Town of Rolesville, NC
Department of Planning

Comments on #SDP-26-0007 - Planning & Zoning: Site Development Plan

Application Number: #SDP-26-0007
Application Type: Site Development Plan
Date: September 11, 2026
Address: 408 E YOUNG ST, ROLESVILLE, NC 27571
Parcel: 1768098727

SHEET NUMBER:
C-2.01

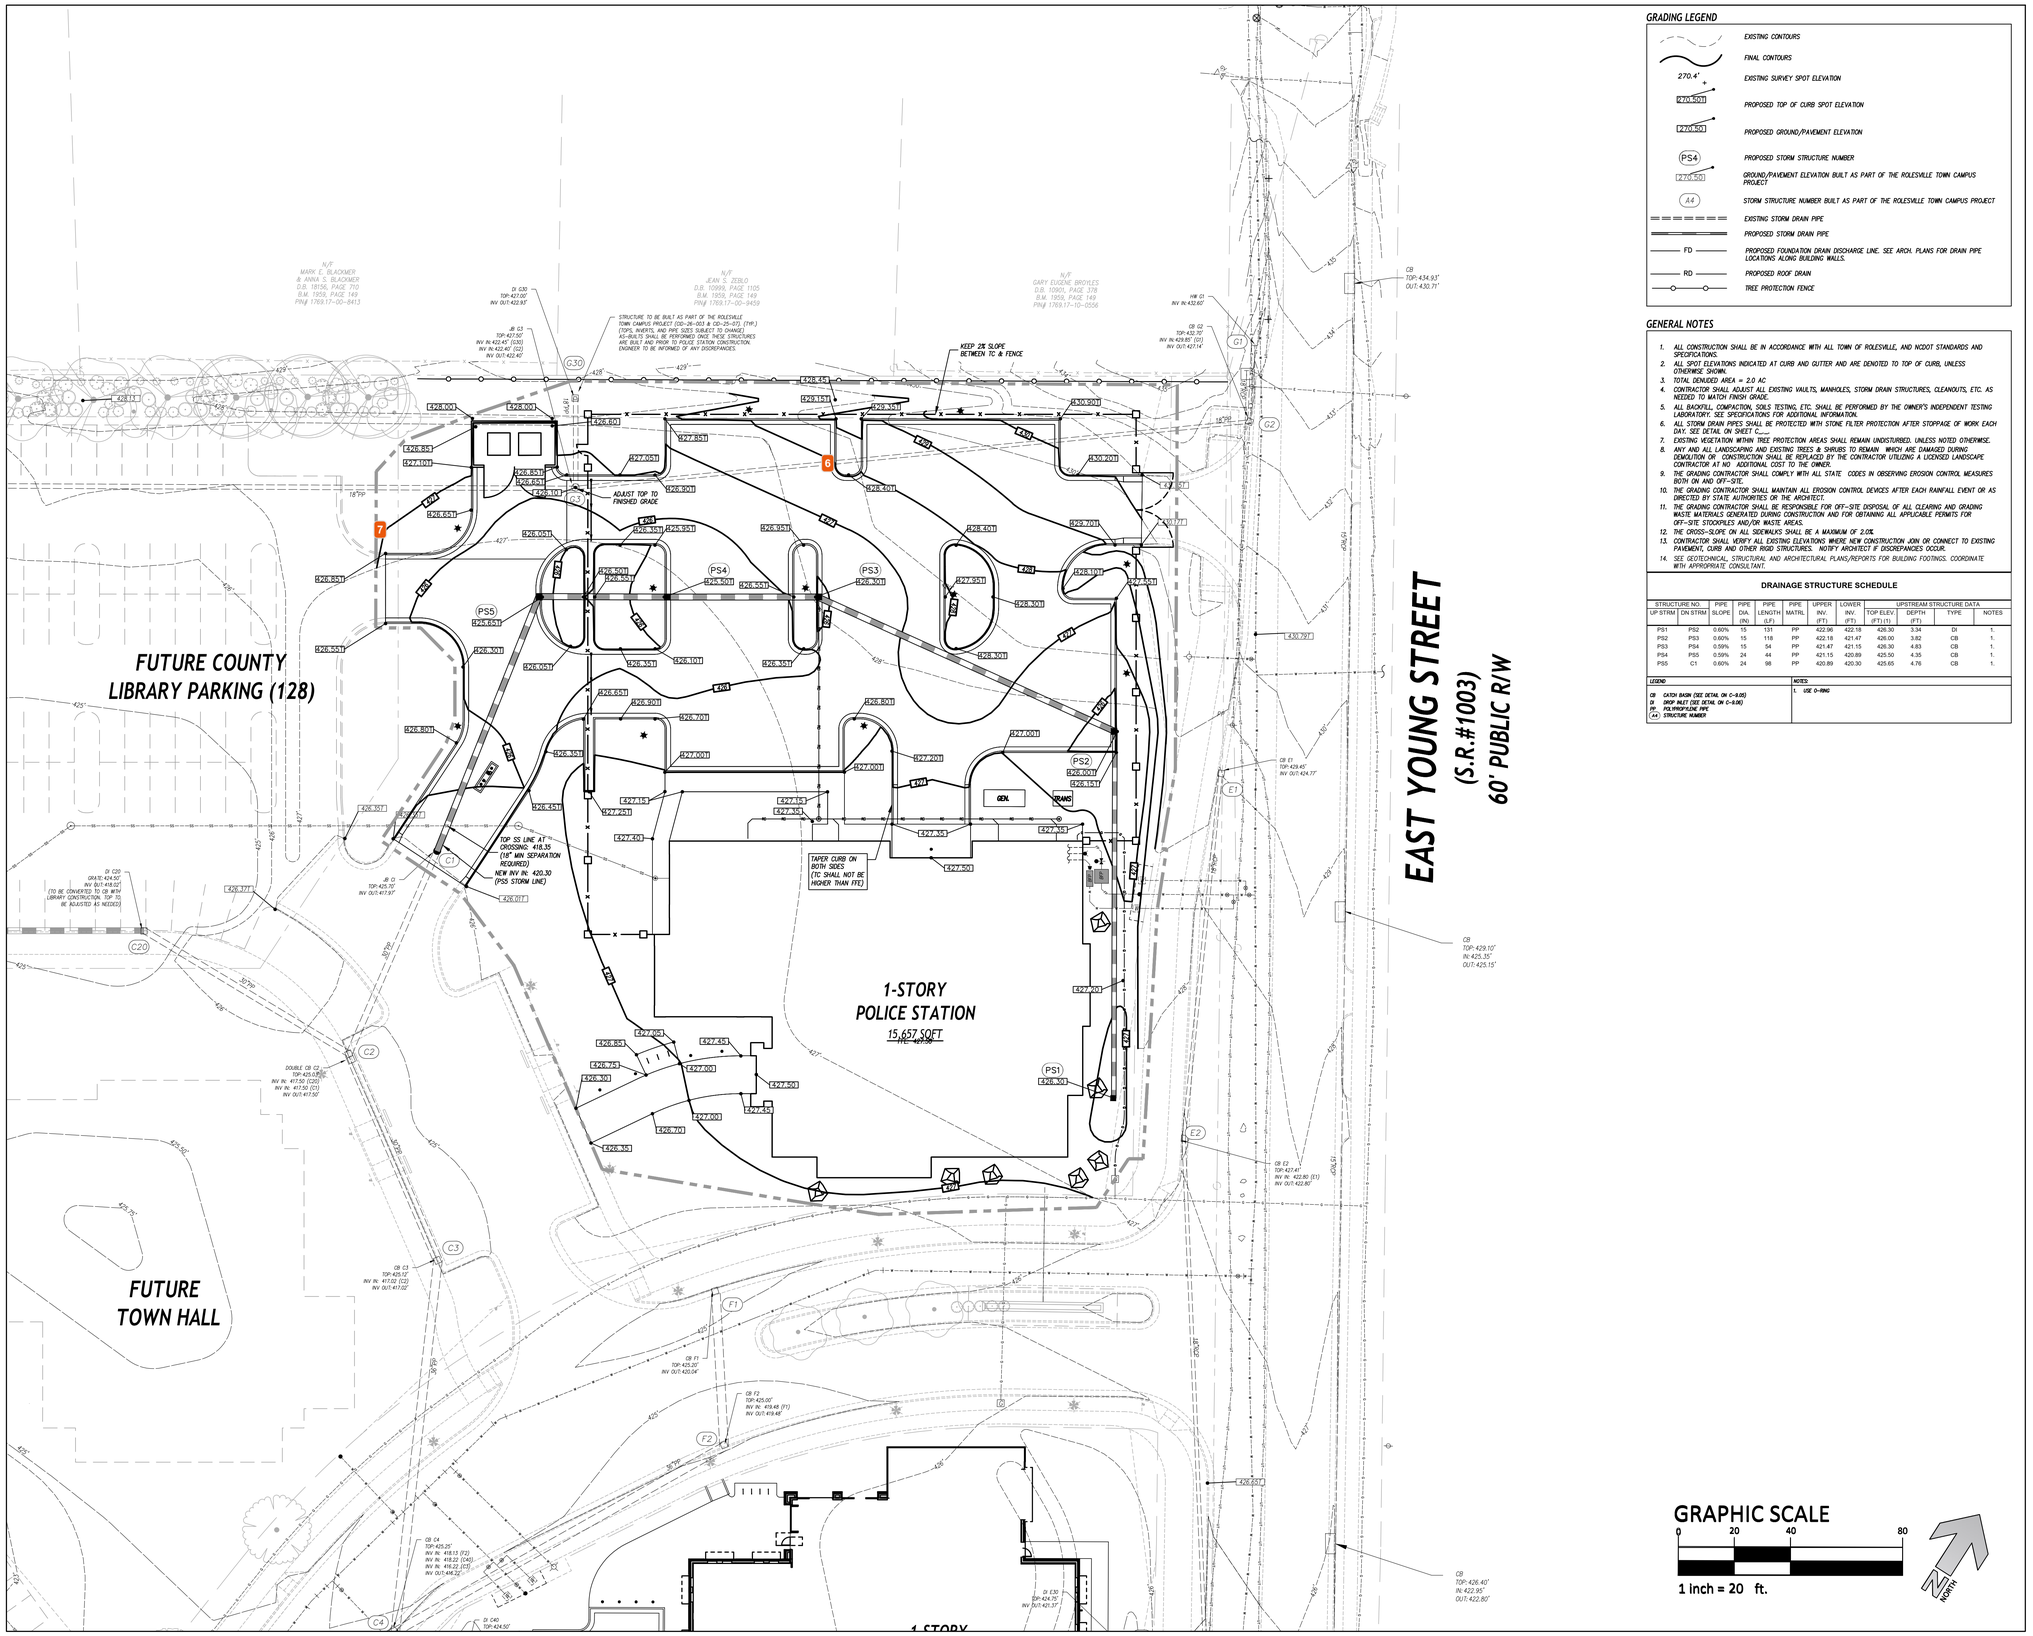
Please review these labels - they appear to possibly match Key Note B.

5 **Jacqueline Thompson**
Please review these labels - they appear to possibly match Key Note B.

SHEET NUMBER:
C-3.01

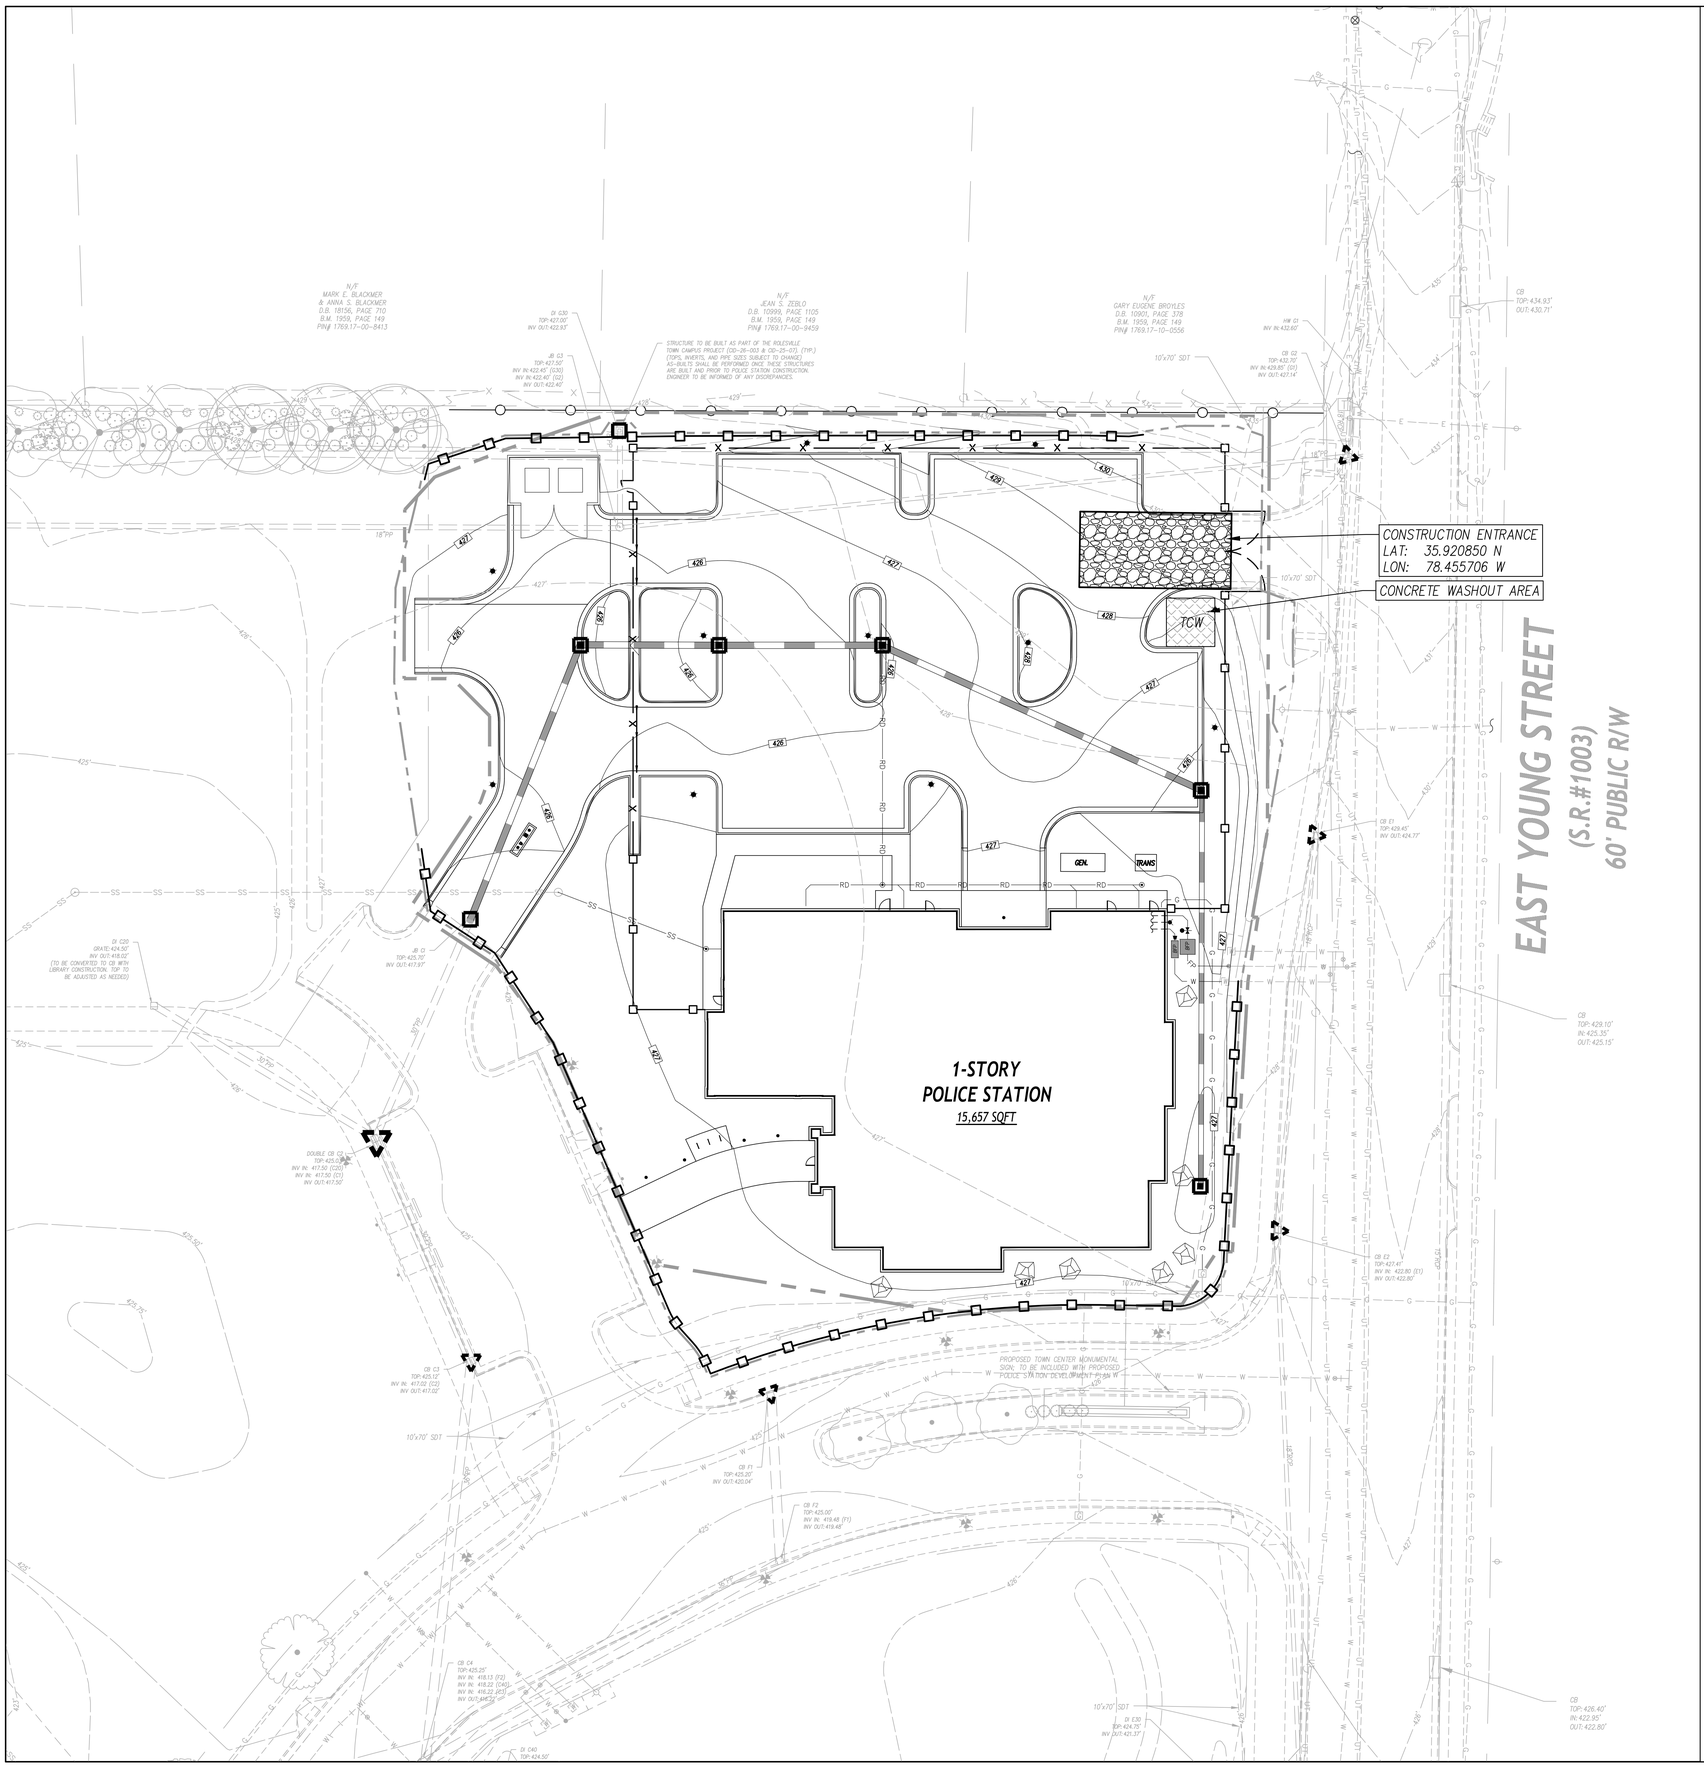
REPEAT: Please clarify if there is any reverse curb - if so, please identify locations on the plans in some way.

6 Jacqueline Thompson
REPEAT: Please clarify if there is any reverse curb - if so, please identify locations on the plans in some way.

7 Jacqueline Thompson
REPEAT: Adjust curb and pavement limits and/or grading to match.

SHEET NUMBER:
C-6.01

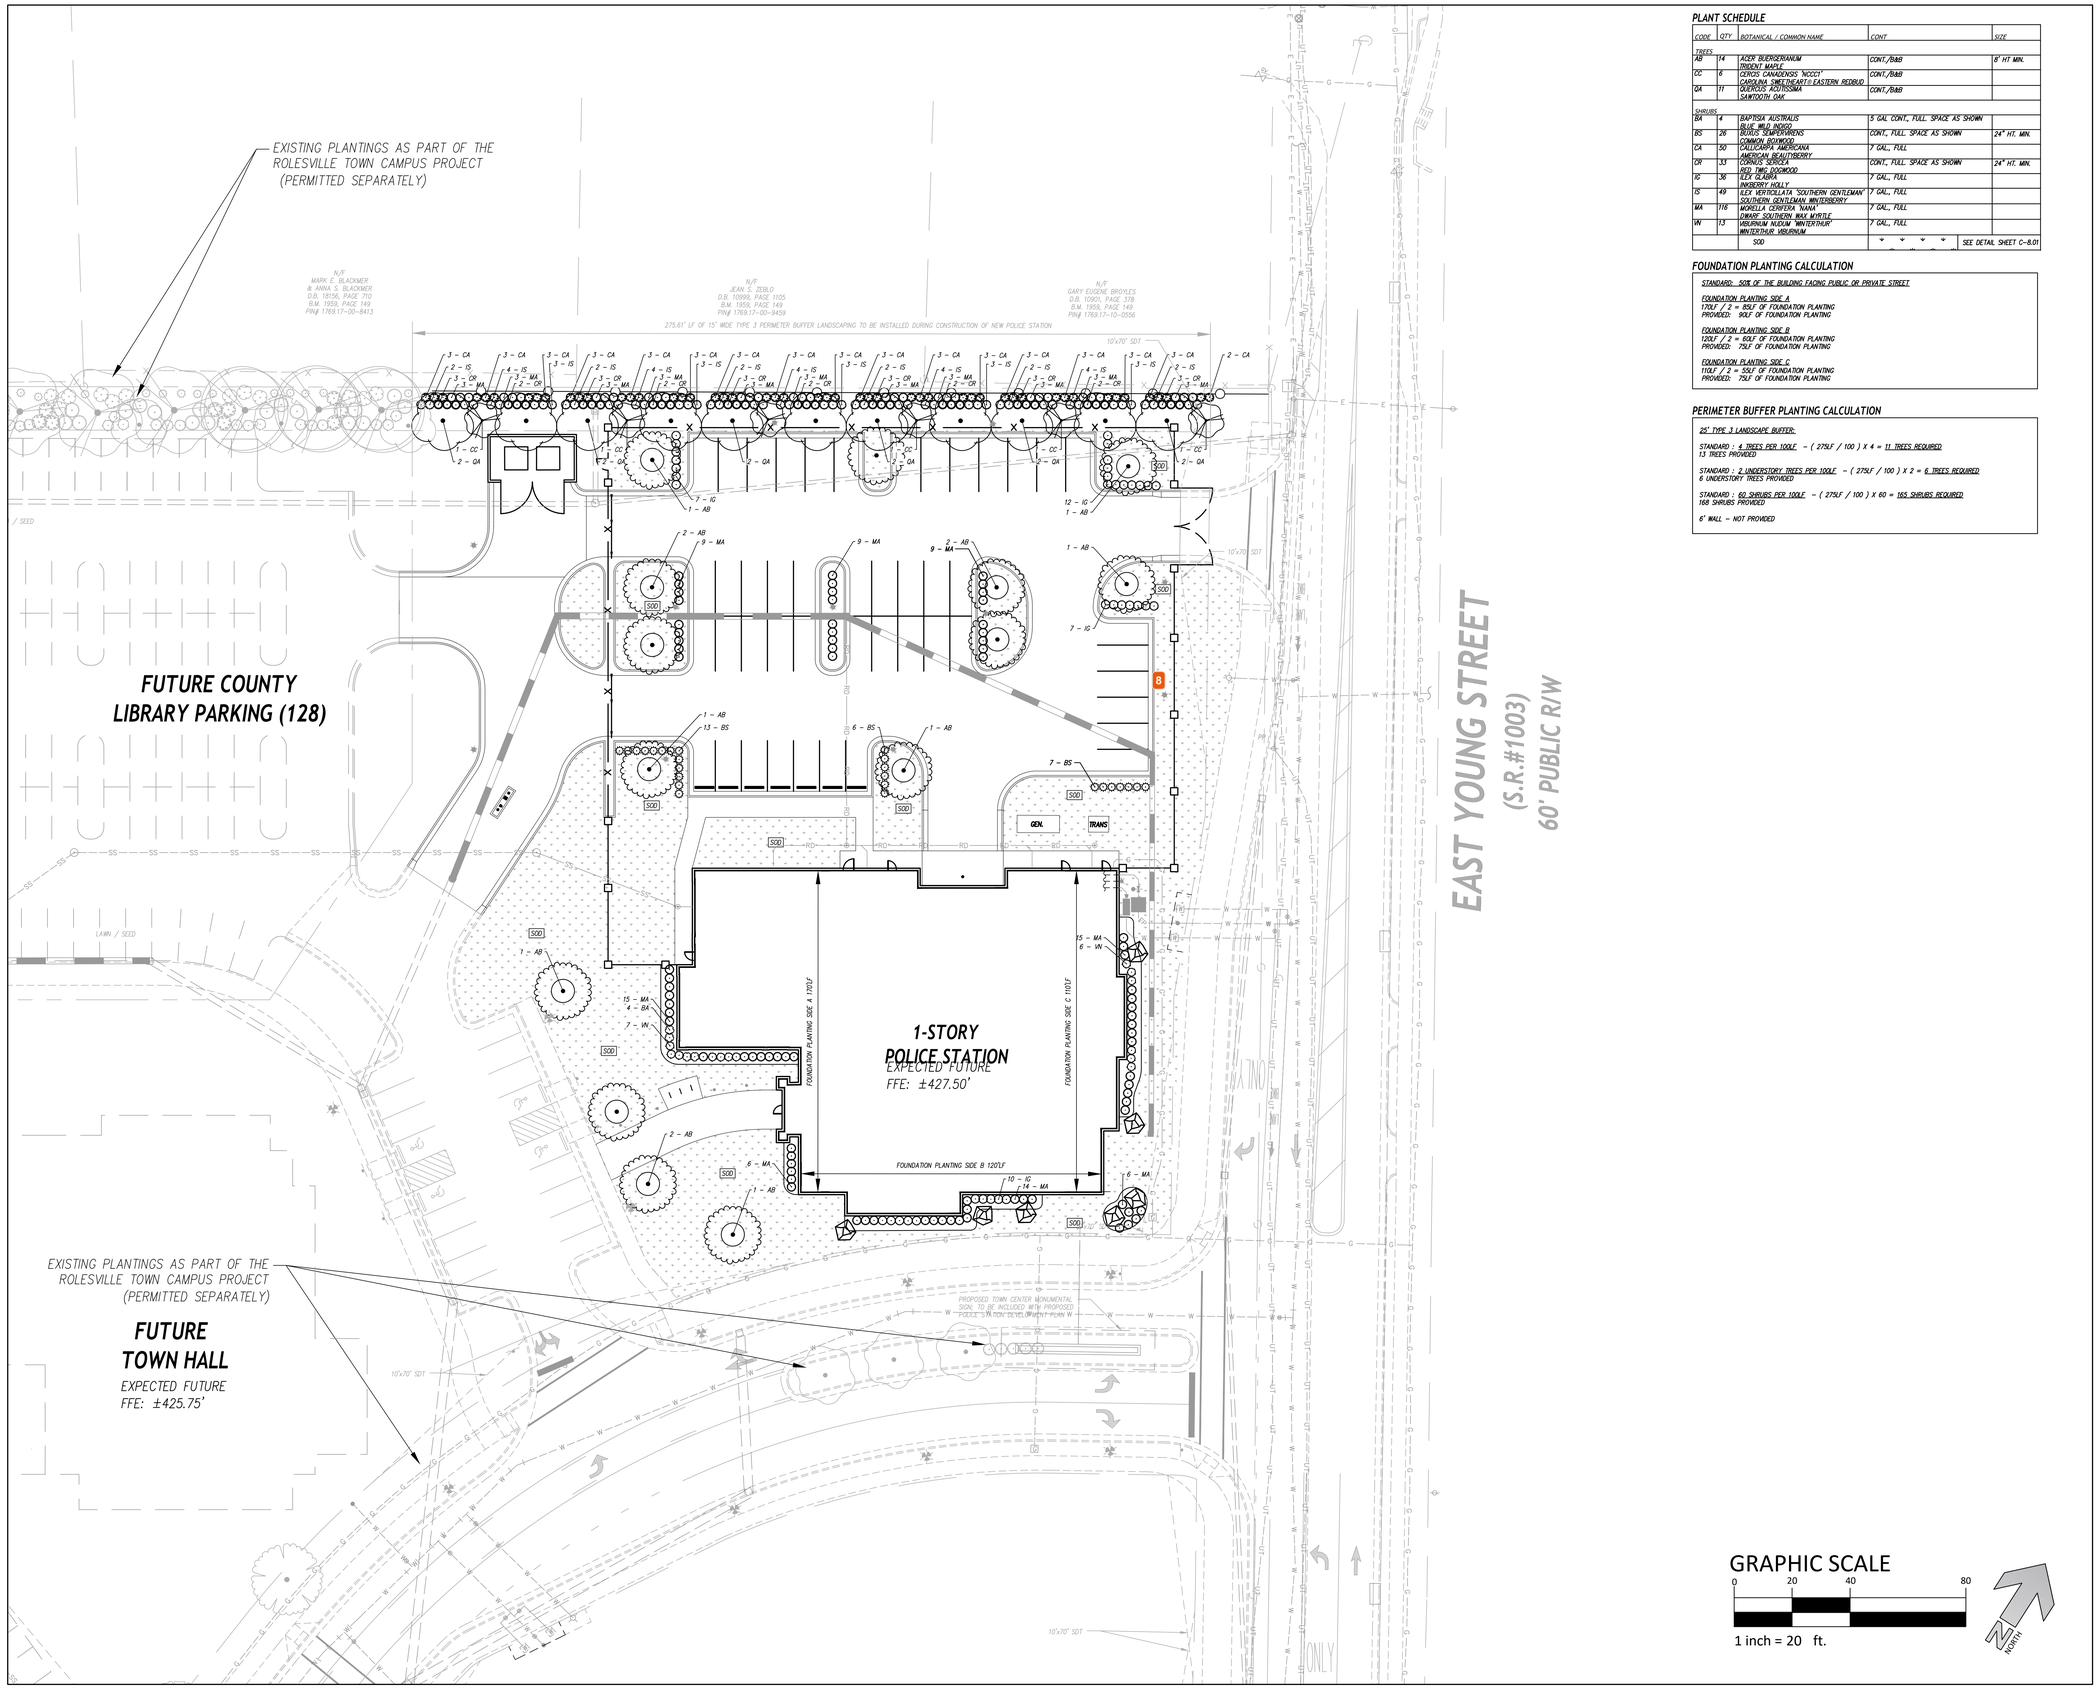
Parking Perimeter Plantings required here.

8 **Stephen Wensman**
Parking Perimeter Plantings required here.
